City of Fredericksburg

Planning and Zoning Meeting Agenda
Wednesday, May 6, 2026 ~ 5:30 PM
New City Hall at East Campus
2818 E. U.S. Hwy. 290
Fredericksburg, Texas 78624

RE: SP-2602, Review Comments for the La Posada Site Plan located at 111 FM2093, Fredericksburg, Texas, 78624

RE: SP-2603 Review Comments for the Bethany Lutheran Site Plan located at 110 West Austin,
Fredericksburg, Texas 78624

1 SITE PLAN
SCALE: 1/16" = 1'-0"

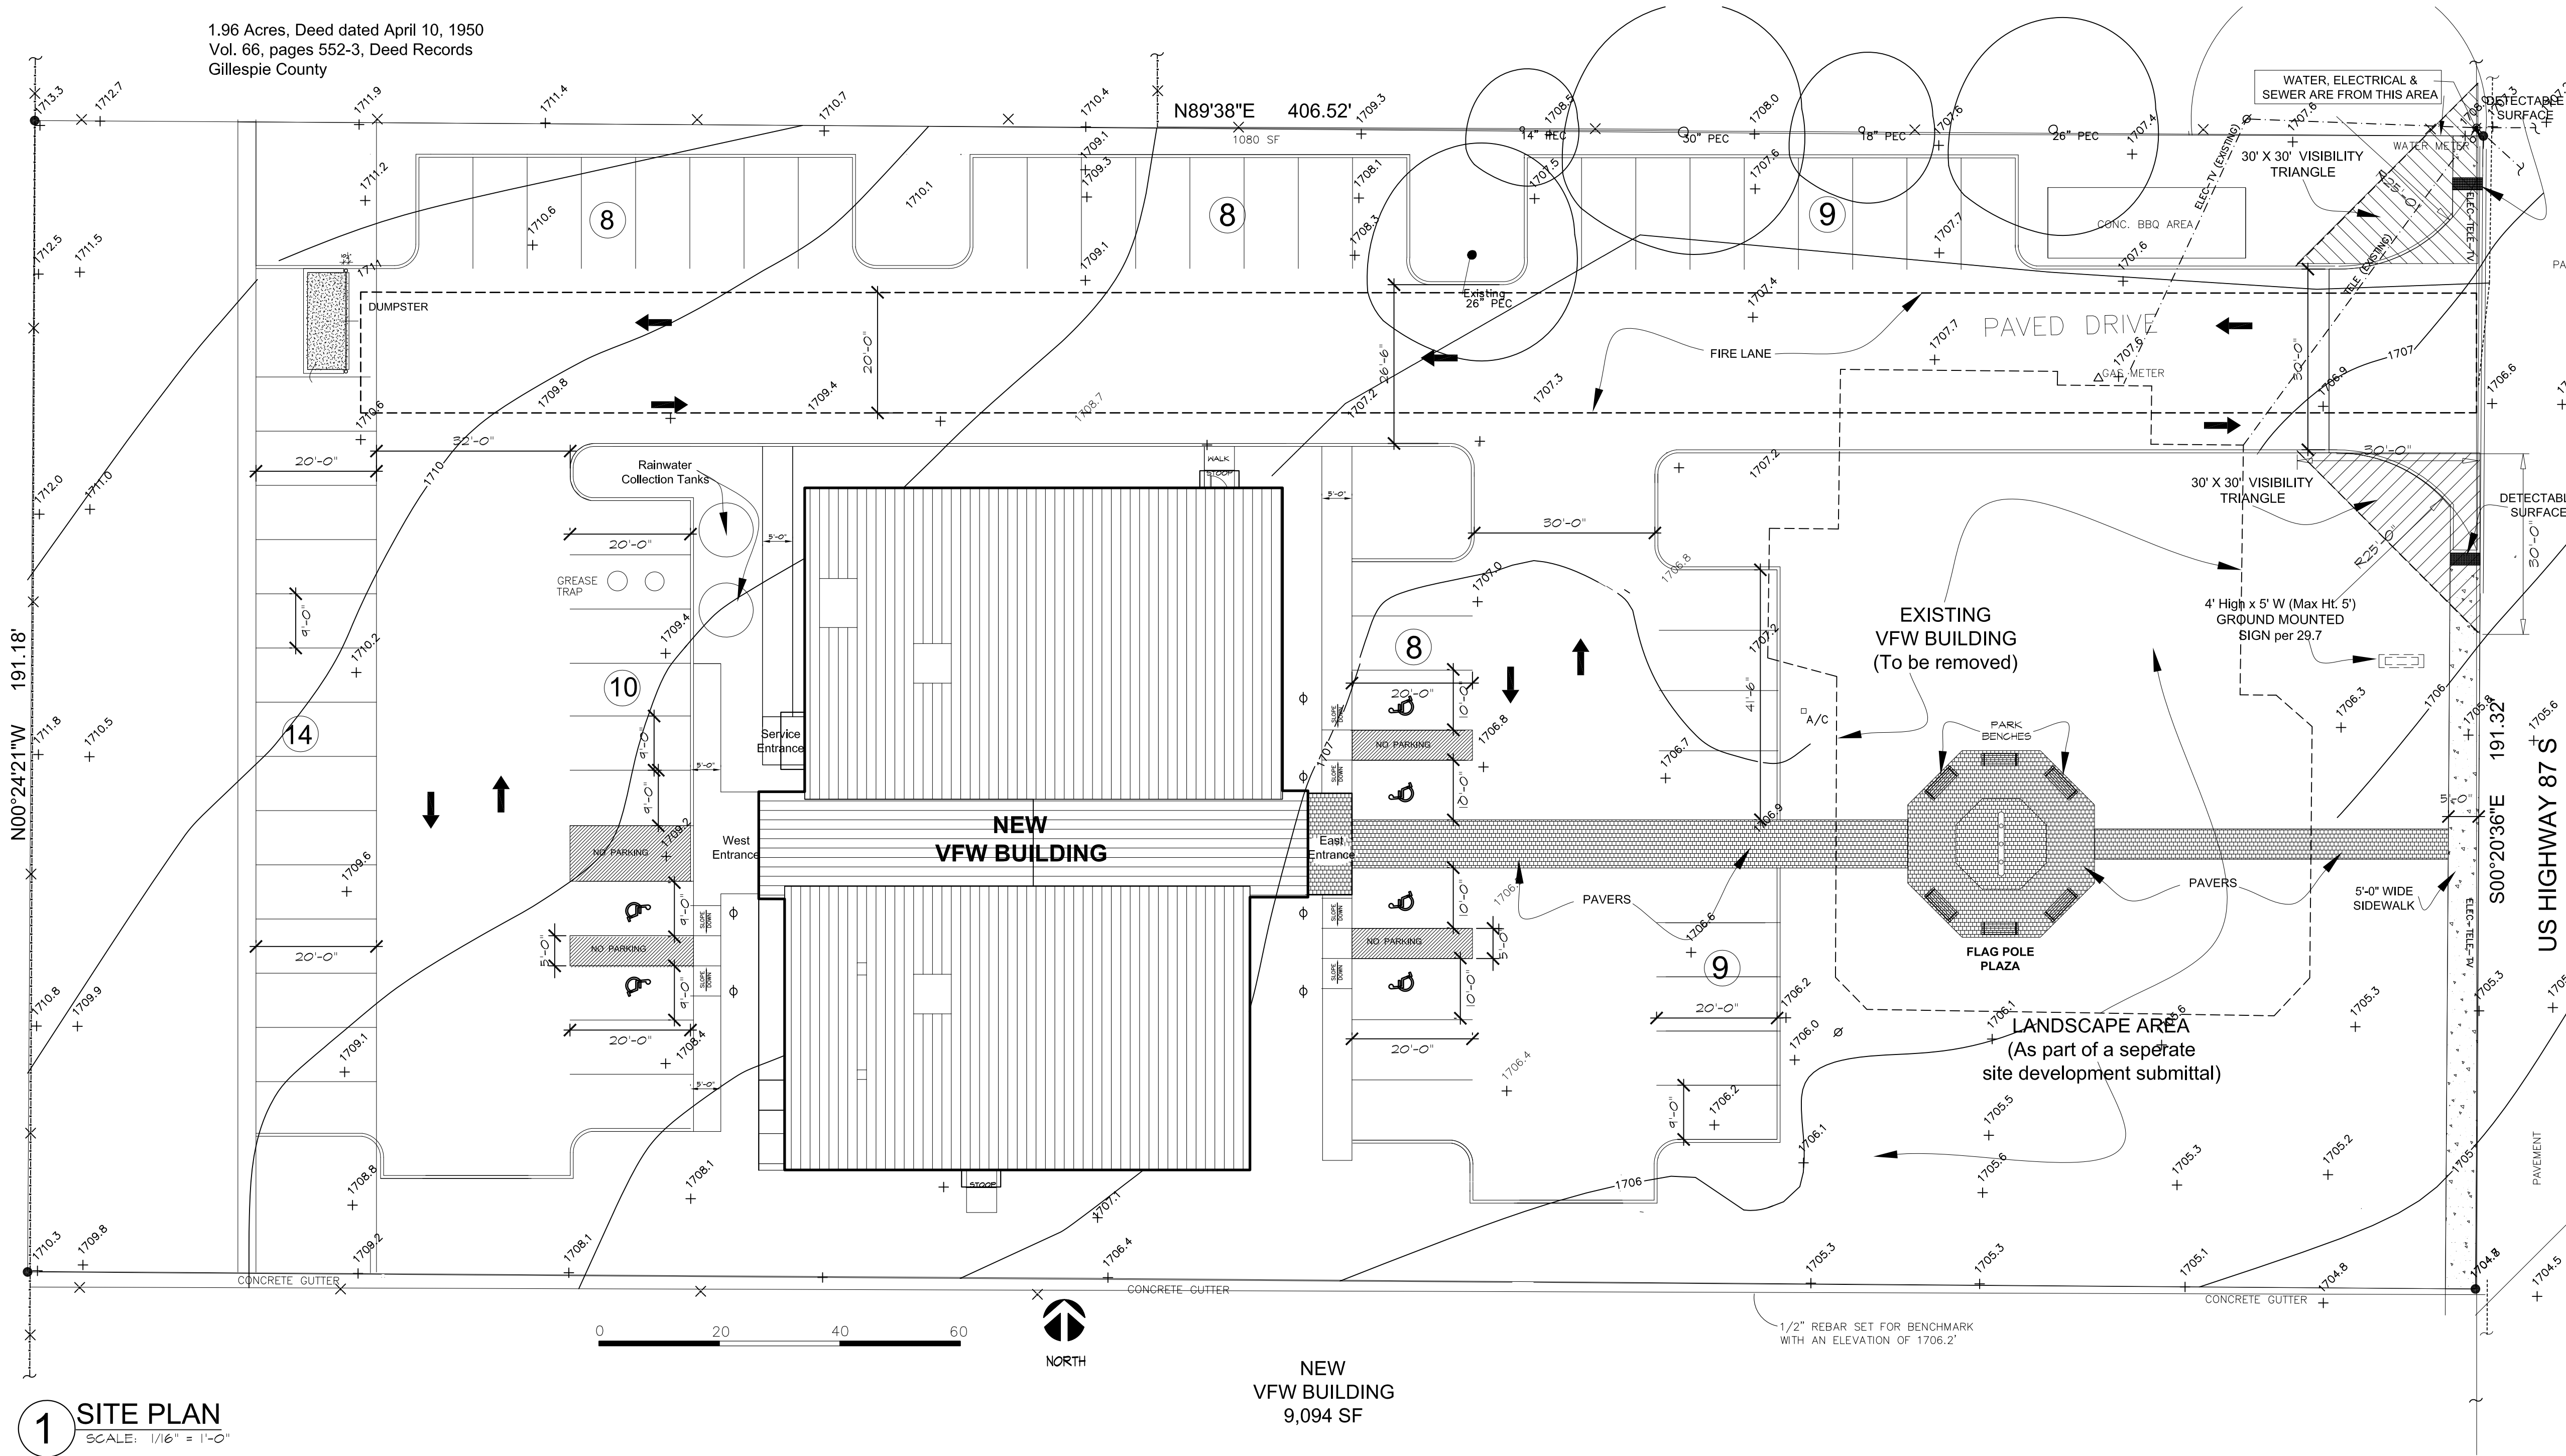
Planning Comments:

1. Provide the location and size of proposed signs, if known, in compliance with Sec. 29.7 of the Code of Ordinances.
 - a. *The sign location is noted on the plan, and it will meet Section 29.7.*
2. Label the location and provide detailed site plan showing size of the existing and proposed landscape areas in accordance with Sec. 7.920 of the Code of Ordinances.
 - a. *The proposed landscape plan will be submitted during the construction document and permitting phase.*

1. Civil construction plans will be required. Utility connections, drainage, parking, etc. will be reviewed in detail at that time.
 - a. *This is correct. Civil construction plans will be submitted at that time.*
2. Please remove unused dimension callouts from the top left part of the drawing.
 - a. *These are removed from the plan.*
3. Please label the width of the proposed parking spaces and ensure they meet section 7.860 of the City's code of ordinances.
 - a. *These dimensions are shown on the plan and meet Section 7.860.*

4. Please dimension ADA parking spaces and loading zones and verify they meet ADA requirements.
 - a. *These dimensions are shown on the plan and meet ADA requirements.*

5. All drive aisles should be 26-ft wide.
 - a. *Drive isles are corrected and shown on the plan.*
6. Please show proposed utility connections and existing utilities in Highway 87.

- a. *Noted.*
8. Please show the curbing and sidewalks in the ROW and align them with the intersection at Highway 87 and Highway Street
 - a. *The curb and sidewalks are within the right-of-way, and they align with the intersection at Highway 87 and Highway Street.*

9. Please make sure the driveway off Highway 87S is TxDOT approved and provide a copy of the approved TxDOT driveway permit when available.
 - a. *We have been coordinating with TxDOT and are working towards a Driveway Permit.*

10. Please show the 30'x30's sight visibility triangles on either side of the driveway. Ensure that no proposed landscaping that could obstruct a driver's line of sight is located within these areas.

- a. *The new building will use the existing utility connections to the 6-inch wastewater line and the 8-inch water line in Washington Street right-of-way. These connections will be located, and the detailed design will be shown in the Civil Construction Plan drawing set.*

- a. *The 30' x 30' sight visibility triangles are shown on the plan.*
